APPENDIX 2-2

SCOPING CONSULTATION RESPONSES

From: Emma Prior <eprior@mkoireland.ie>
Sent: Thursday 26 March 2026 10:07
To: Robert Kennedy; Thomas Blackwell; Karen O'Neill; Keelin Bourke
Subject: FW: 240505 - EIA Scoping Request for Overall Substitute Consent for Meenbog Wind Farm, Co. Donegal - Minor Amendment

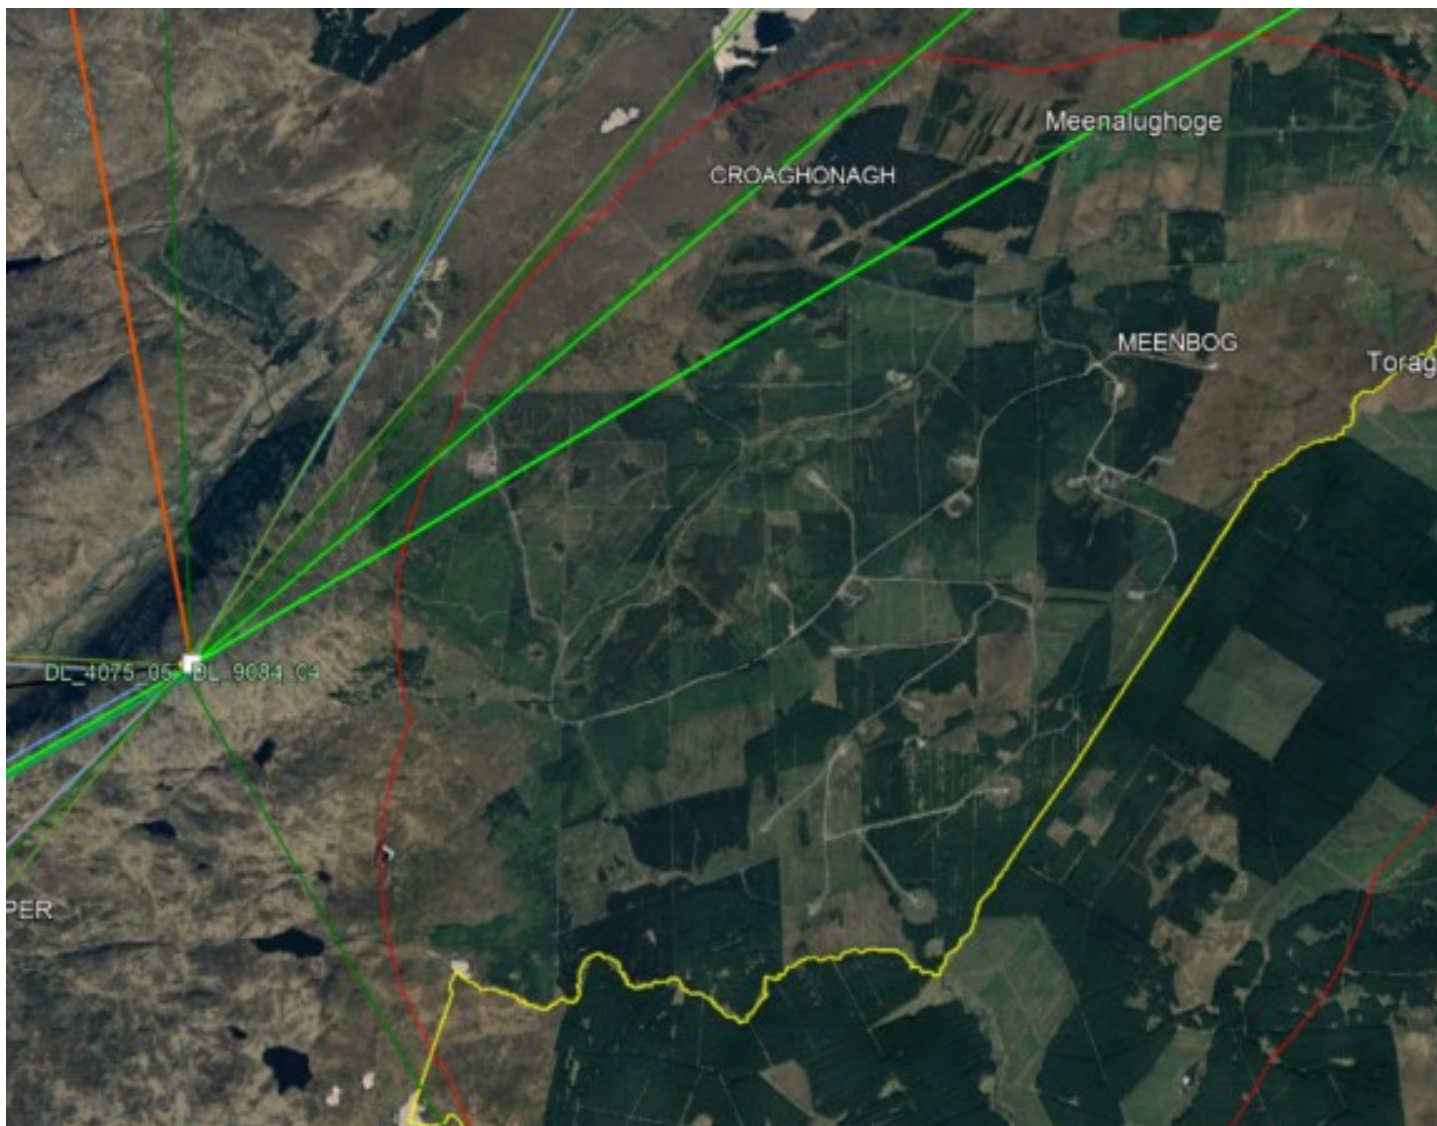
We have 2 transmission links within the proposed area that would be at risk, the end points of the transmission links are below, if you could keep a buffer of 100meters radius away from this transmission path when placing your turbines and send them on for further analysis. Please keep sending new development analysis requests to MobileNetworksTXN@eir.ie for Eir Mobile and the Eir fixed network.

#	Band	A-end				B-end		
Link1	11Ghz	DL_4075	54°43'2.64"N	7°56'35.88"W	<--->	DL_4076	54°47'29.12"N	7°45'1.15"W
Link2	11Ghz	DL_4075	54°43'2.64"N	7°56'35.88"W	<--->	DL_4078	54°53'27.88"N	7°38'5.67"W
